Application for Departure from Standard

Project Name	M2P - Petone to Melling Walking and cycling path	Date:	15/11/2019
Client Name	NZTA	Ref:	DS-P2M-01
Client Project Manager	Chris Robertson NZTA		
AECOM Project Manager	Section 9(2)(a)	Author	Section 9(2)(a)
KiwiRail Project Manager	Section 9(2)(a)		
Subject	Application for Clearance Departure from Standard

PROJECT NUMBER: 60306339
SHEET TITLE: PETONE TO MELLING ALIGNMENT PLAN EXTENT OF KIWIRAIL DEPARTURES
SHEET NUMBER: 60306339-SK-7601

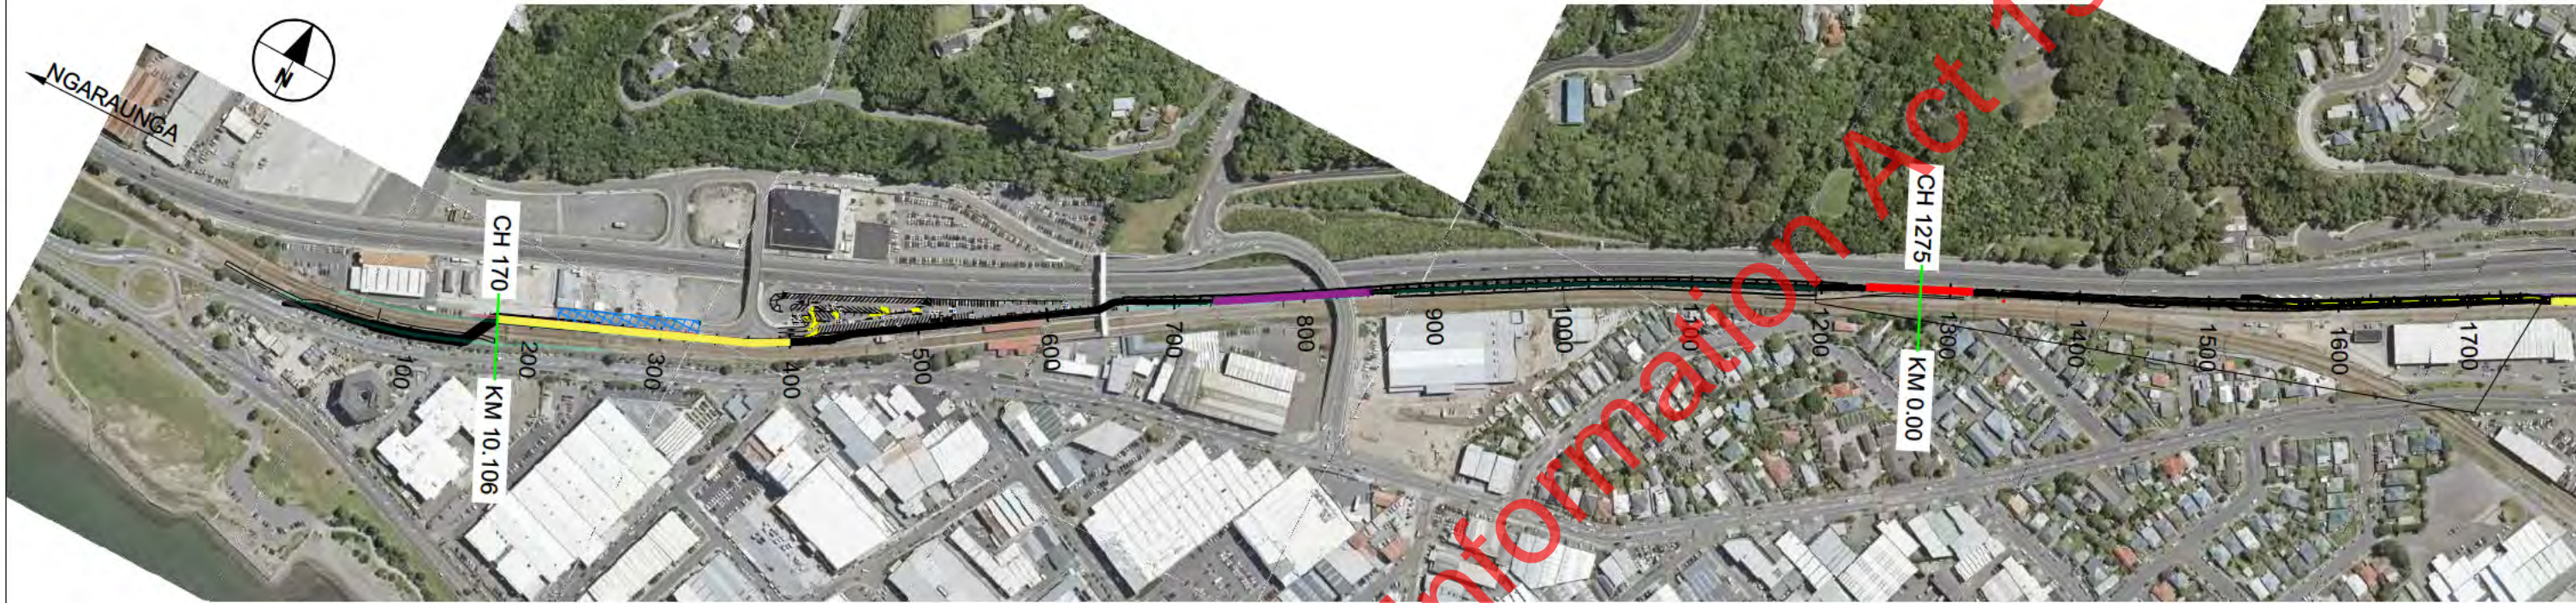
- Departure 1 – Hutt Road Vicinity; 3.0m track clearance
Km 10.106 to Km 10.361 (M2P Ch 170m to Ch 430m)
- Departure 2 – Korokoro Bridge; 5.0m track clearance
Km 10.670 to Km 10.790 (M2P Ch 740 to Ch 860)
- Departure 3 – Rail Safety Track Turnout; 2.1m track clearance
Km 11 189 to Km 11 239 (M2P Ch 1250 to Ch 1315)
- Departure 4 – North of Safety Turnout; 3.0m track clearance
Melling Line Km 0.5m to Km 1.781 (M2P Ch 1775 to Ch 3066)

Plan - Rail Safety Turnout

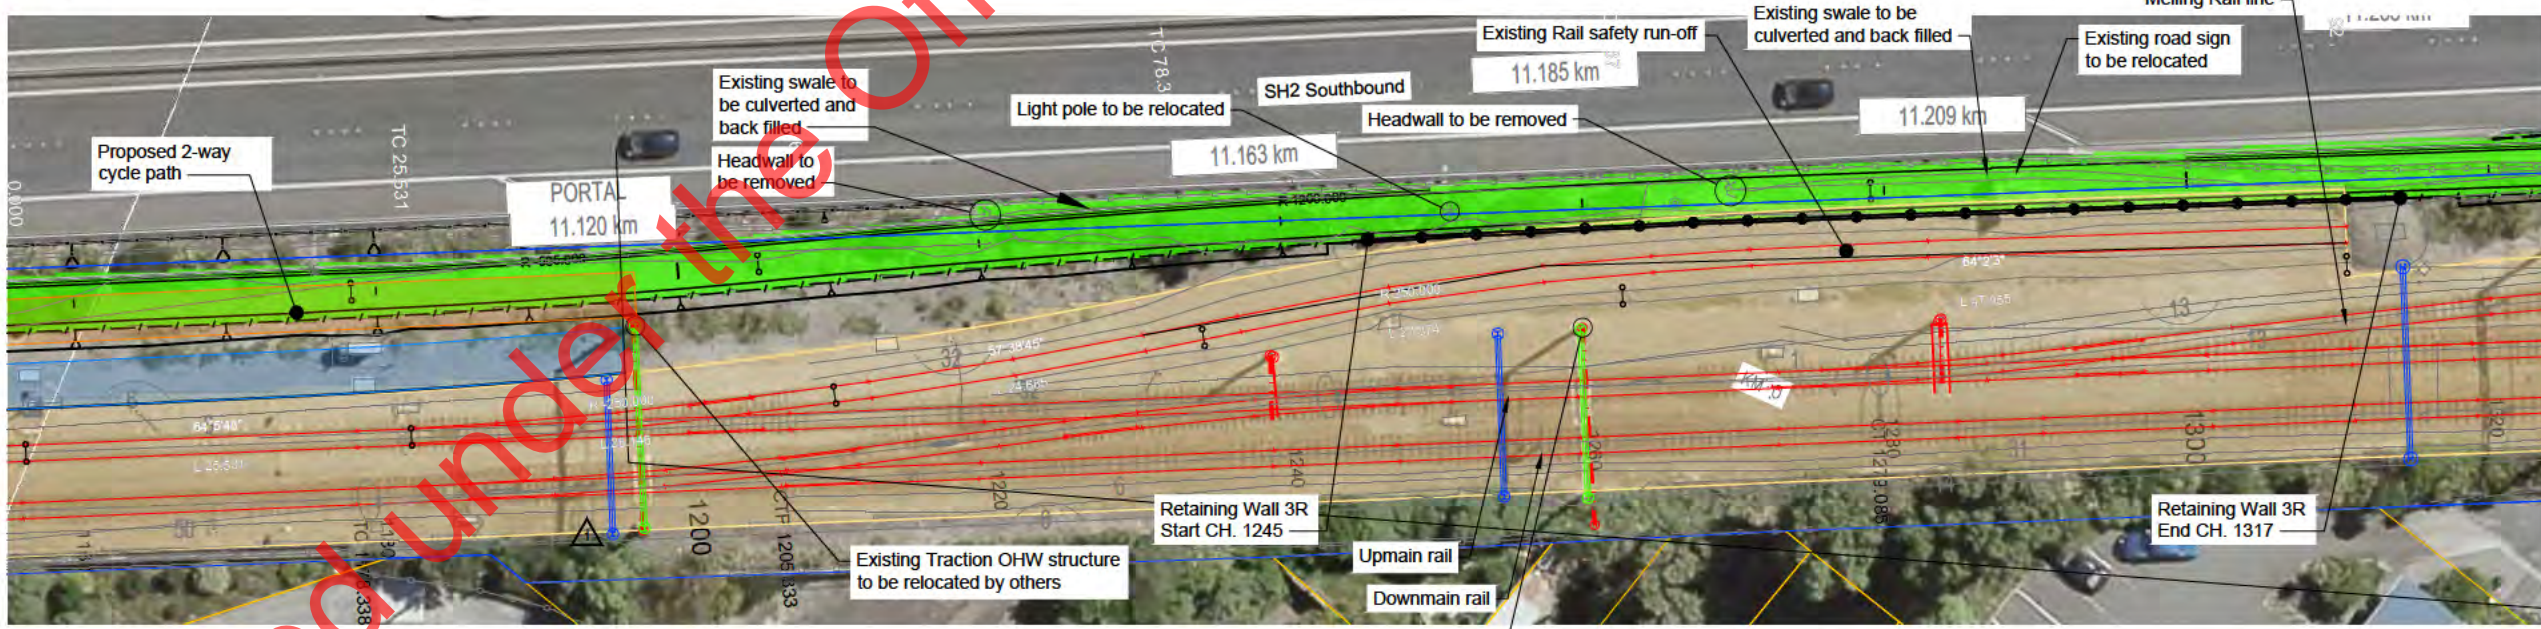
Revised sketch taking on board a 2.1m clearance to centre of safety runout and 0.6m deflection to our light poles

Note:
 Typical section Chainage 750 -850
 (*1) The width of the proposed KiwiRail maintenance access track is 2.5m from ch. 750 to ch. 850.
 (*2) The safety clearance is reduced to 2.5m from ch. 805 to ch. 855 (through KoroKoro Overbridge)

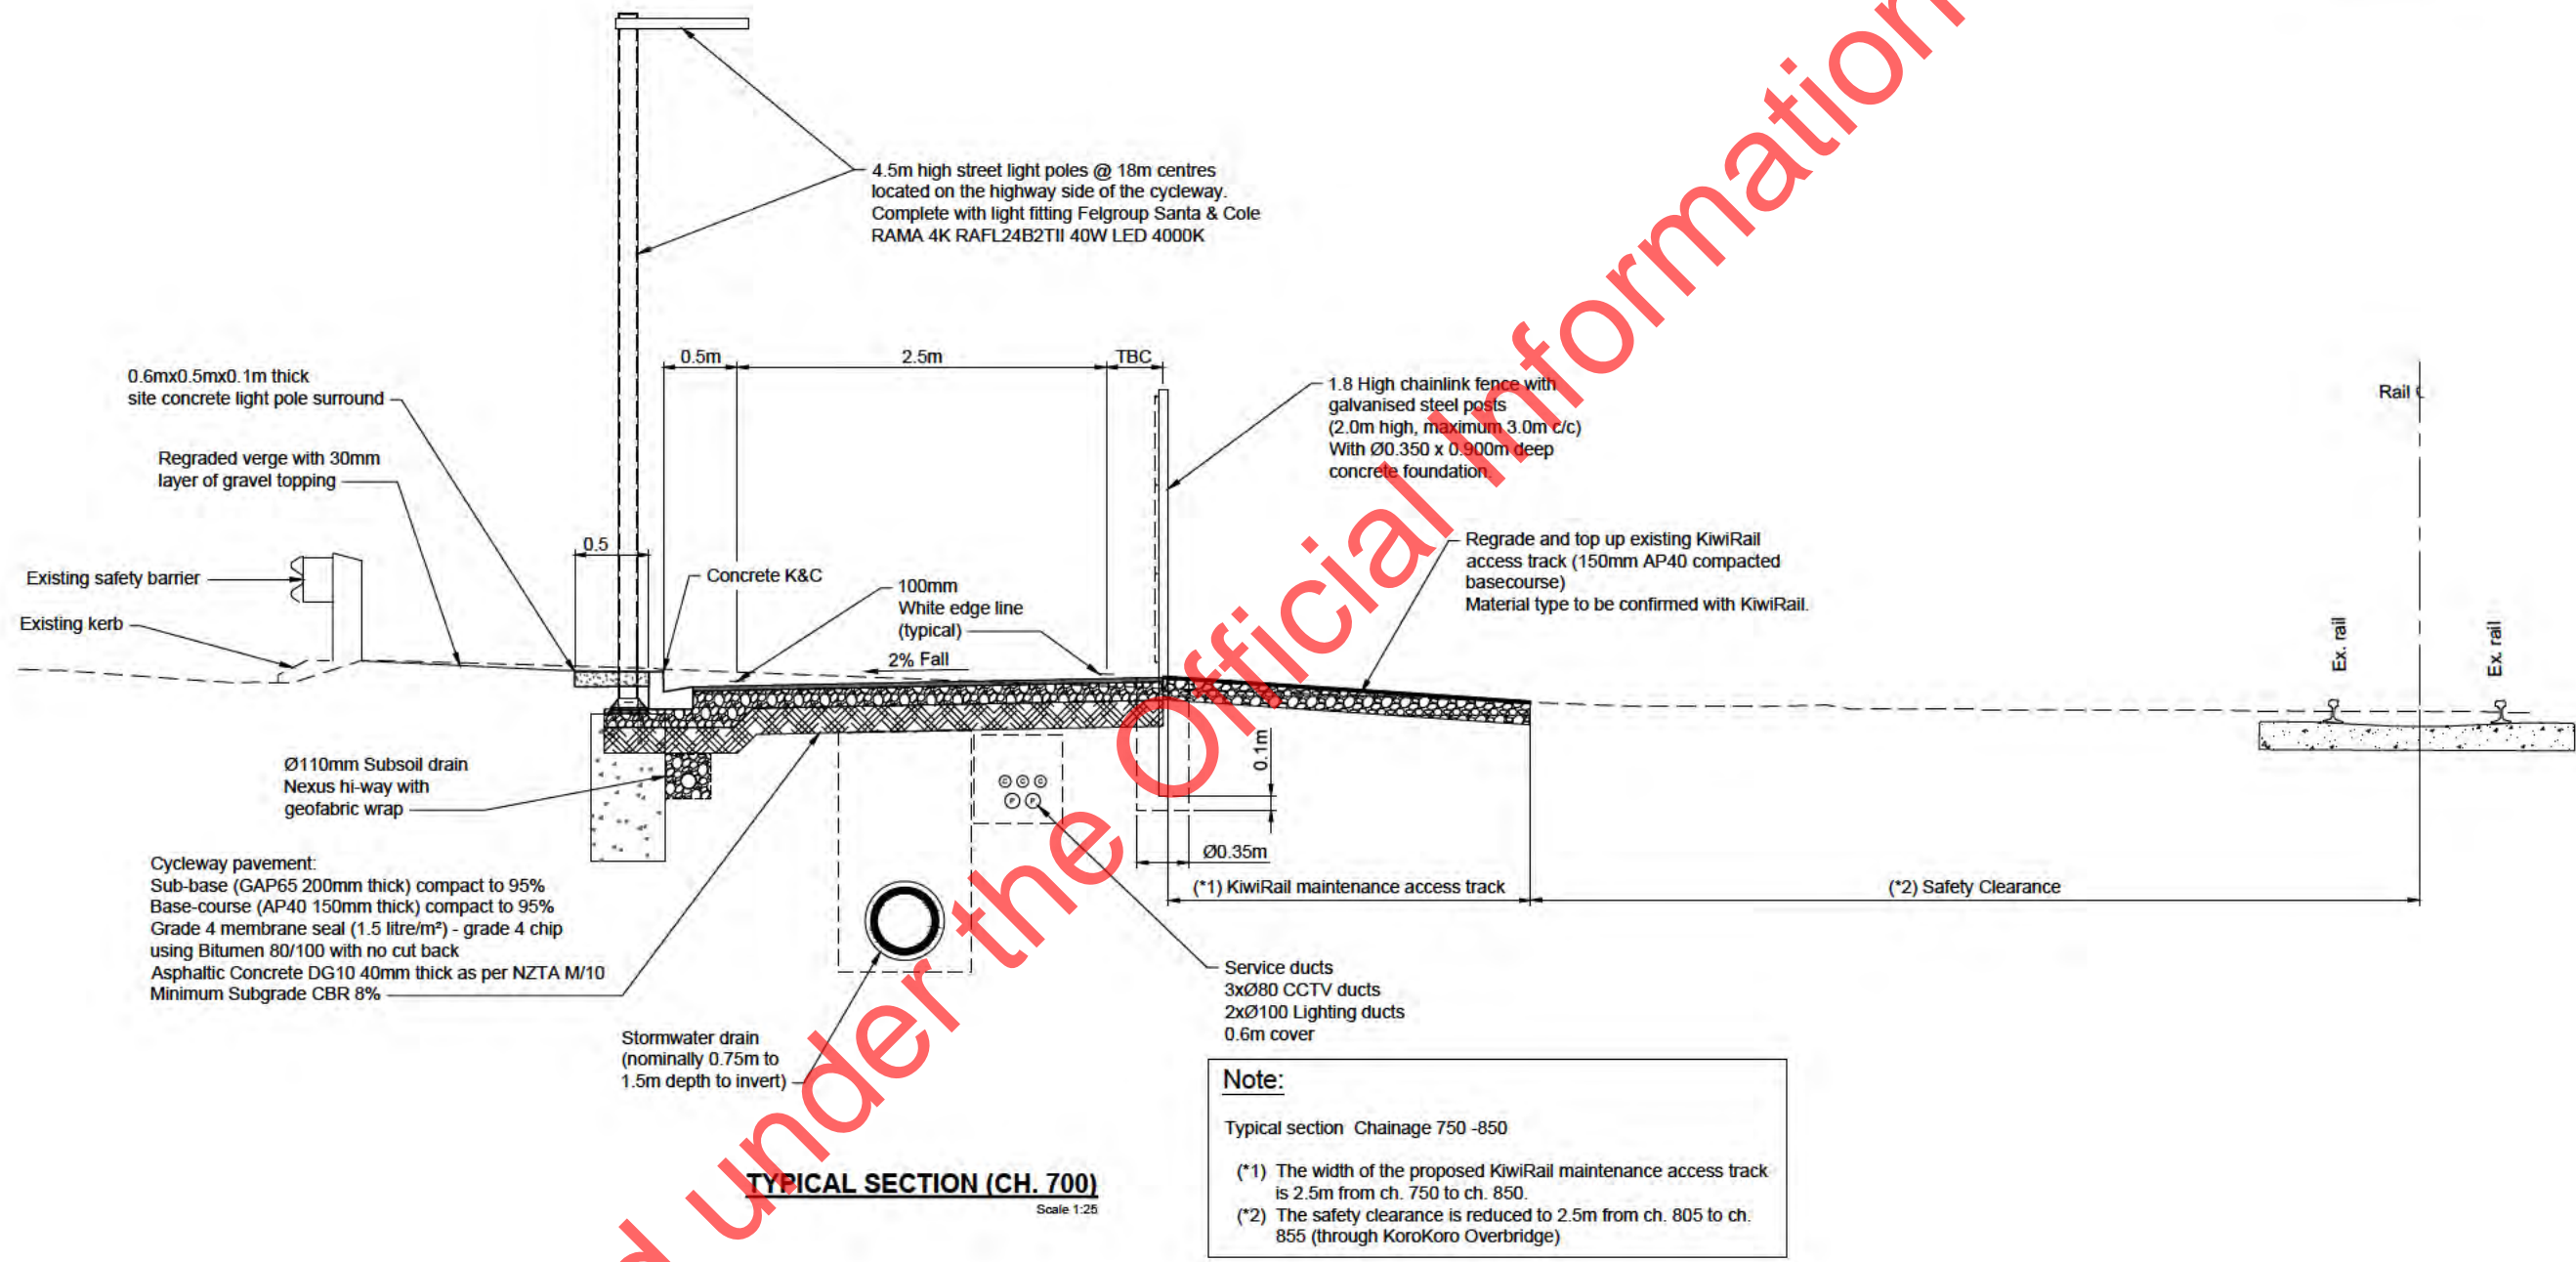
Korokoro Bridge Area Km 10.670 to Km 10.790 - Clearance minimum 5.0m. Relevant documents to this clearance are attached and as follows:

This section of the walking and cycling path includes maintenance access from Km 10.630 to Km 11.109. The majority of this section meets the standard clearance of 6.0m from track centreline, however 120m in the Korokoro Bridge vicinity reduces to 5.0m from track centreline.

We are seeking a clearance departure to 5.0m from track centreline to match what is currently in operation at the moment with a 2.5m maintenance access that is 2.5m from track centreline. We note this width is reduced from the standard but allows sufficient width for vehicles to access between the outside of the toe of the ballast and the fence line if required.

PROJECT NUMBER: 60306339
SHEET TITLE: PETONE TO MELLING TYPICAL CROSS SECTION CH. 1270
SHEET NUMBER: SK-7622

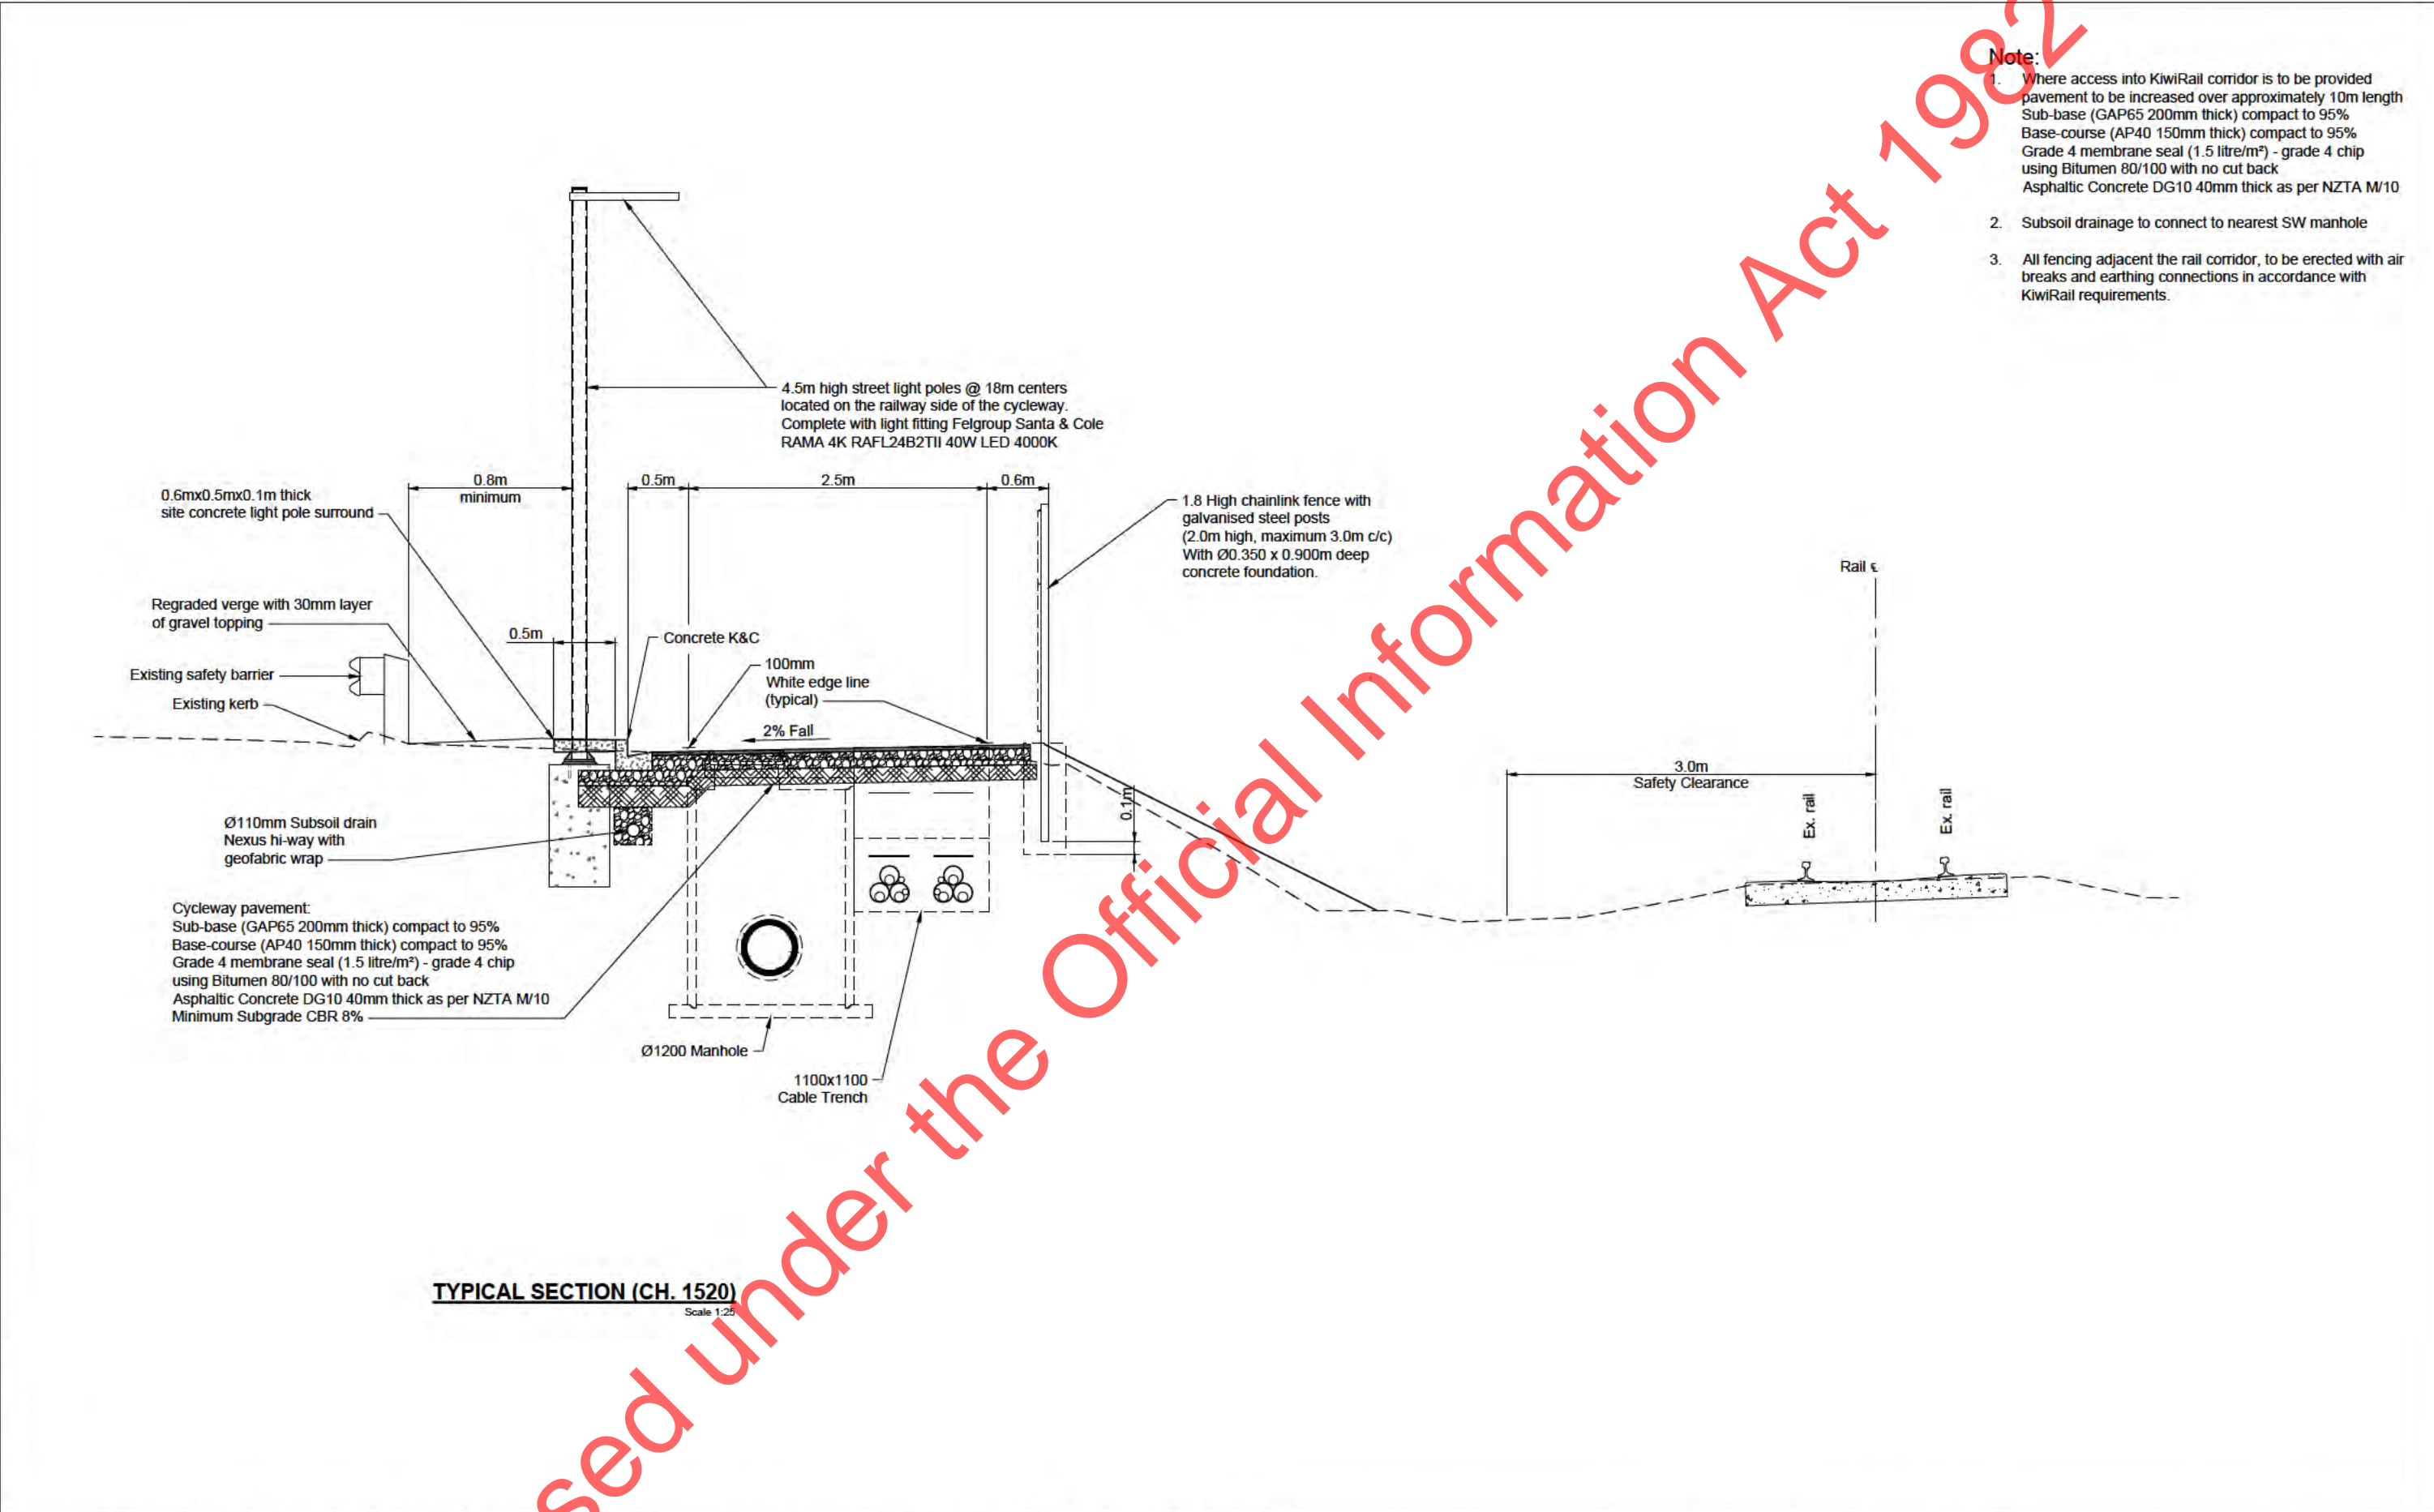
Rail Safety Track Turnout - Clearance 2.1m to fence line Km 11 127 to Km 11 237. Relevant documents to this clearance are attached and as follows:

This very restricted clearance is shown on plan Sk7622. The path width in this area has been reduced from the standard and the existing road restraint barrier replaced with a narrower section to help increase the clearances to the existing track centreline. Possible relocation of the safety track turnout was reviewed but there has been agreement to leave the safety track in place and accept the reduced clearance.

This 2.1m track clearance has been accepted with KiwiRail on the premise that the track is a rail safety turnout only for use in emergencies and not an operational main. Maintenance for this section of track can be accessed either end of the turnout area if required.
